10/542,908

Office Action Summary

VAN CASTEREN, DOLF
HENRICUS JOZEF

FIG. 2

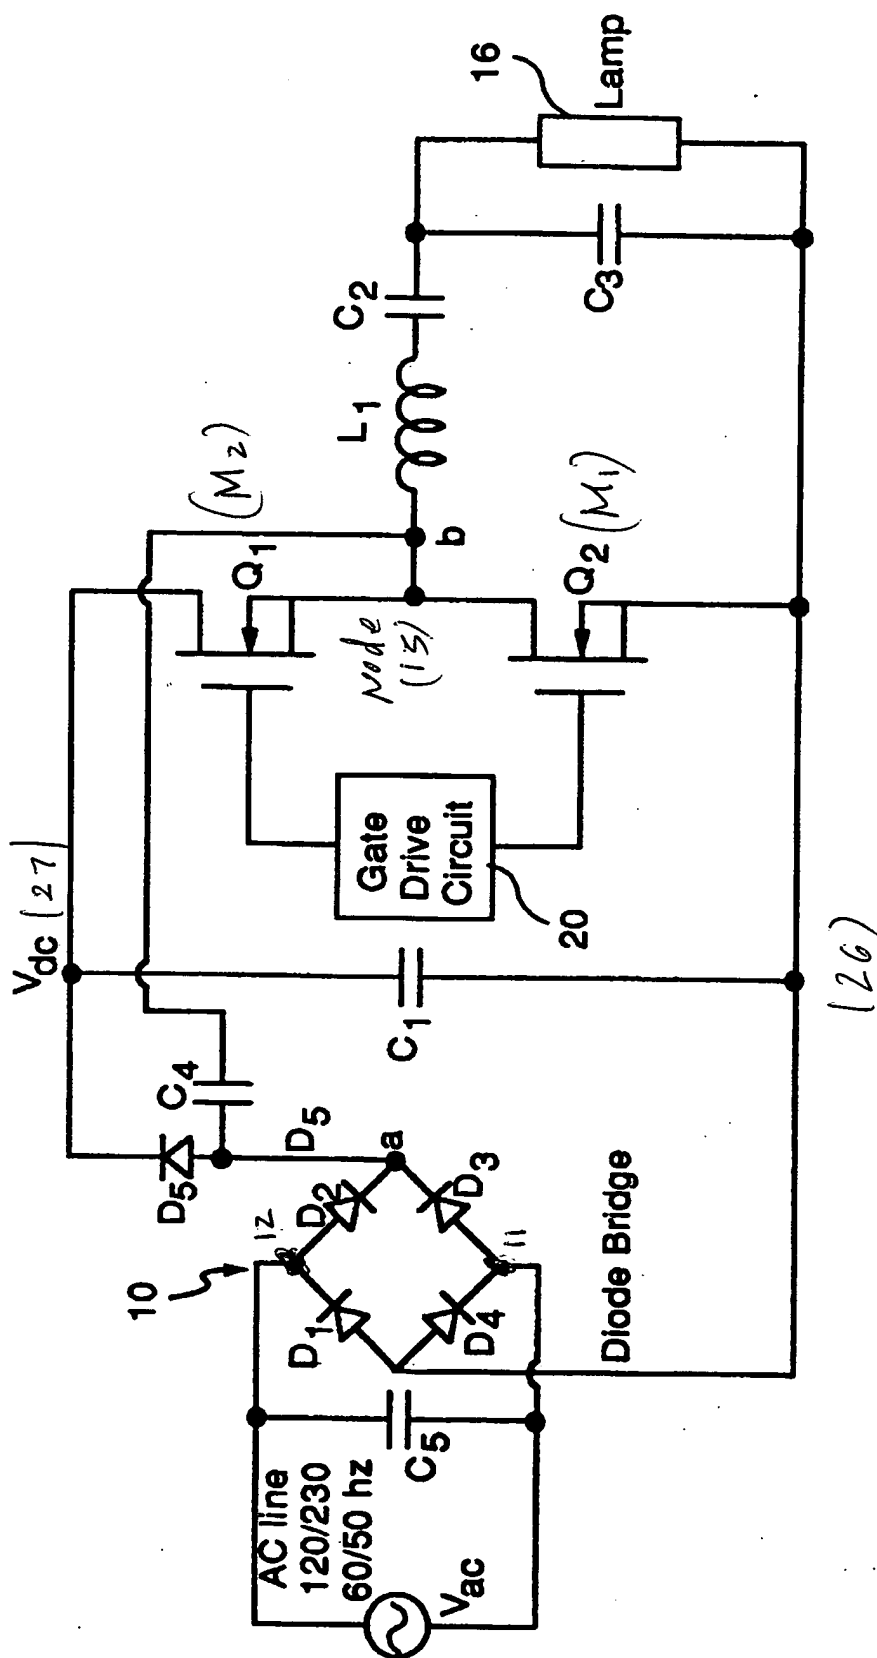
Regarding claim 1, EL-Hamamsy et al disclose (see attached element devices as show in figures 2), a circuit for driving a load(16), comprising: two input terminals (11,12) for connection to a source of a supply voltage (Vac); a first and a second output terminal (26, 27) for connection to the load (16); at least one inductor (28) coupled between one of the output terminals and a corresponding connection node (15); at least one arrangement (gate drive circuit(80)) comprising a switch (M1)(Q2)coupled between one of said input terminals (11) and one of said connection nodes (15), a diode (D5) being connected between said one connection node(15) and the other input terminal (12); a control unit(20) for controlling said one or more switches (M1, M2)(Q1 and Q2), (see col.3, lines 53-67 to col.65) ; characterized in that each arrangement (80)(Q1 and Q2) and corresponding diode (D5) are designed to allow the voltage over the opened switch (M1) of said arrangement to return to substantially zero before said switch (M1) is closed, the control unit(20) being designed to provide a signal for closing the switch (M1) when a substantially zero voltage over said opened switch (M1) is detected. See figures 31-3f, col.4, lines 4-67.

Regarding claim 9, EL-Hamamsy et al disclose (see attached element devices as show in figure 2 and comprising the steps of: a gate drive circuit (20) for turning on a switch (M1) for providing current through an inductor (28) to the load(16); and for turning off said switch (M1) when the current through the inductor (28) reaches a determined value; characterized in that after turn-off of the switch (M1) the current is directed so that it continues to flow until the voltage over the switch is substantially zero, at which time the switch (M1) is turned on again. See figures 31-3f, col.4, lines 4-67.

Regarding claim 3, EL-Hamamsy et al disclose the characterized in that the switches (M1,M2) as showed in claim 1 or figure 2.
